# ALTERNATOR INSTALLATION INSTRUCTIONS

## OLD STYLE DISCONTINUED

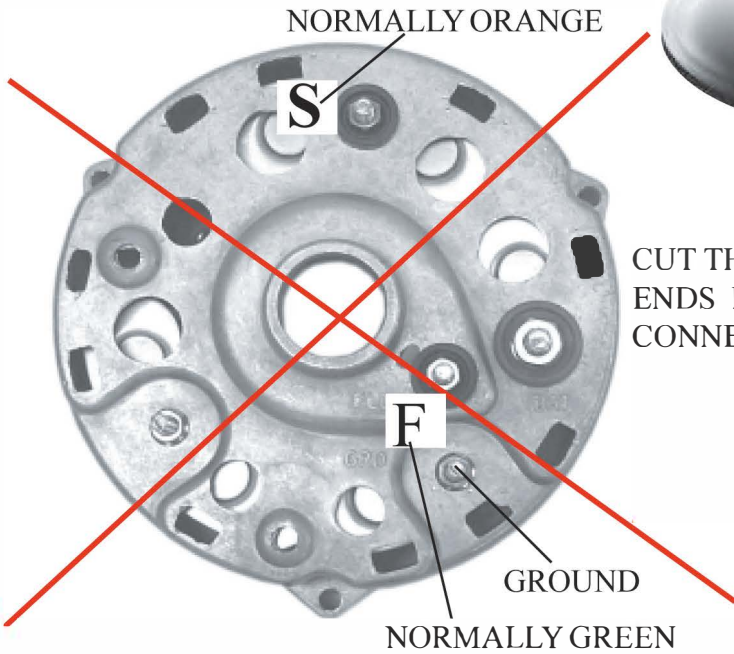
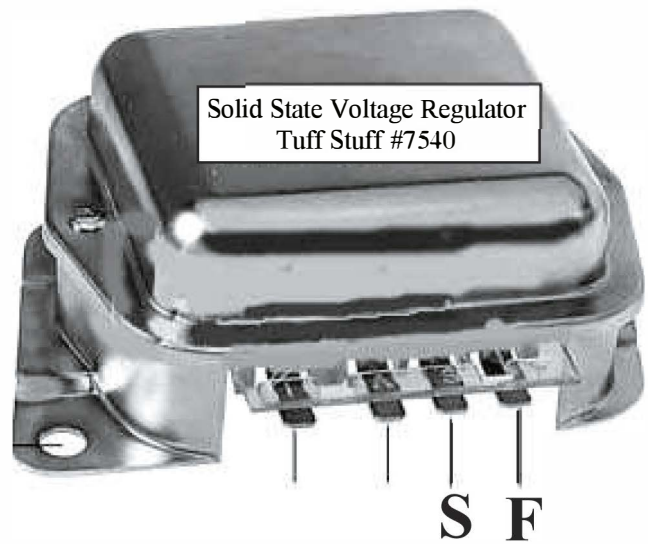
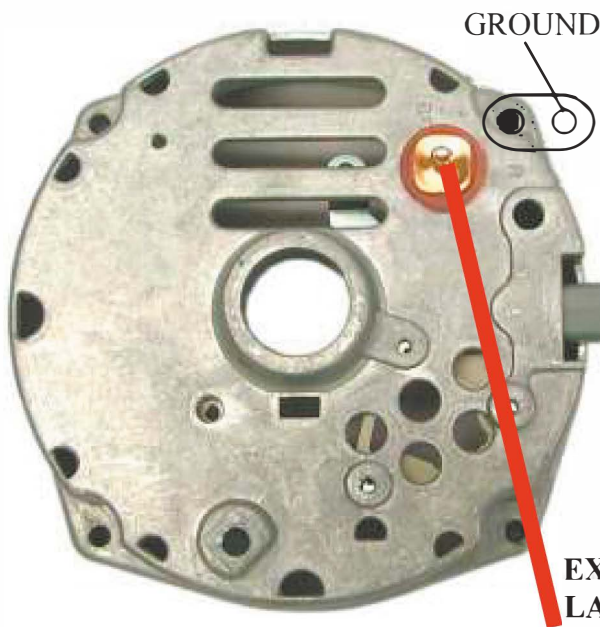
CUT THE EYELETS OFF THE ORIGINAL HARNESS WIRE ENDS FROM "S" & "F" TERMINALS. CRIMP ON NEW CONNECTORS PROVIDED

**YELLOW TO "S" ON REGULATOR  
THROUGH HARNESS**

**GREEN TO "F" ON REGULATOR  
THROUGH HARNESS**
